REGIONAL MEMORANDUM

No. 1423 s. 2025

**CONSTRUCTION OF LIBRARY HUB: MODIFICATION OF ROOFING DESIGN
(STEEL TRUSSES)**

DRAWN / PREPARED BY:	CHECKED BY:	REVIEWED BY:	NOTED BY:	APPROVED BY:	PROJECT TITLE:	SHEET NO.:
AR. GARY D. AGCAGUI TA/MA/III/ESSD	ENGR. CESO C. MANJONAN Engr/III/MA/ESSD	ENGR. III/TA/IV-300	SARAH Q. CASILGA Chief/ESSD	TOLENTINO G. AQUINO Director IV	REVISION OF LIBRARY HUB ROOFING	A1
					SHEET CONTENT:	
					LOCATION:

1 FRONT PERSPECTIVE
A

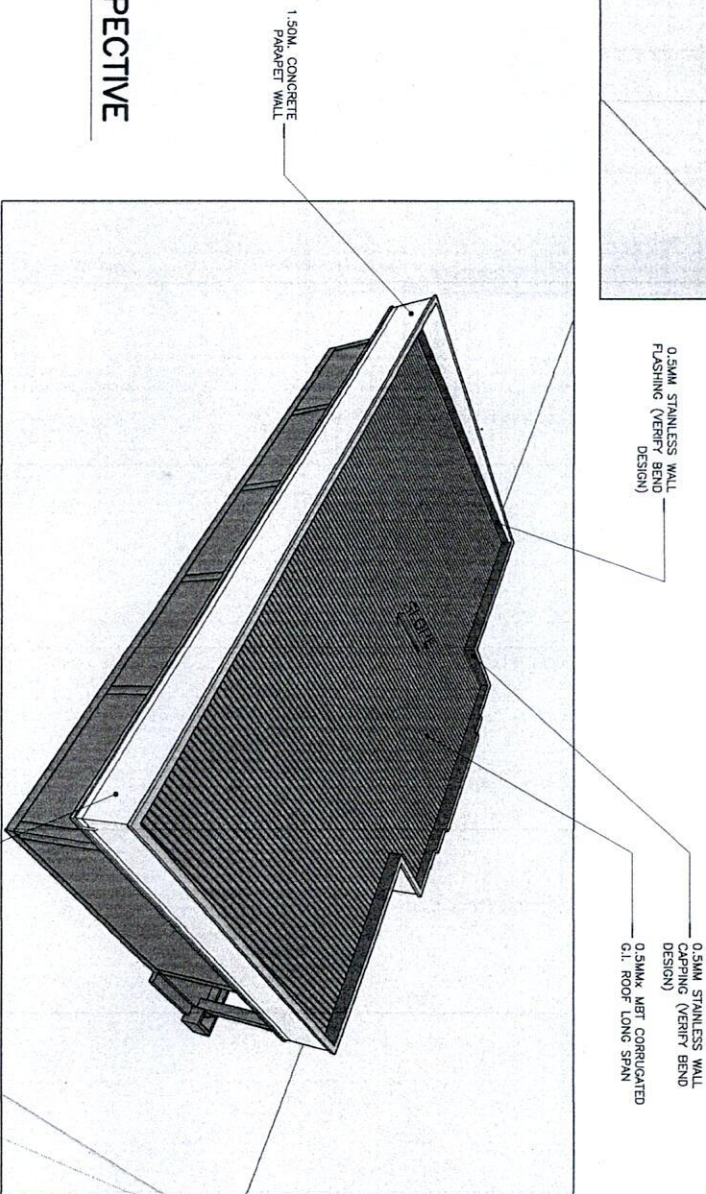
1. Attached are the plans and working drawings for the modified roofing/steel trusses for the Library Hub projects:
2. The modifications are hereby prescribed for the following purposes:

- a. To eliminate the recurring problem of leakage in the inside concrete gutter, which has been the primary cause of damage to the exterior ceiling;
 - b. To provide greater durability and resistance against strong winds brought about by the extended height of the parapet wall;

- c. To facilitate easier maintenance of the gutter system, since the inside gutter (made of stainless steel, 0.50 mm thick) is relocated to the rear side, with a provision of overflow pipes on both ends;

- d. To address the unavailability of specified truss materials in the local market due to the distinct nominal sizes indicated in the plans;
 - e. To reduce extensive heat in the hallway where ceiling air ventilation is situated, by relocating the said ventilation away from the hallway.
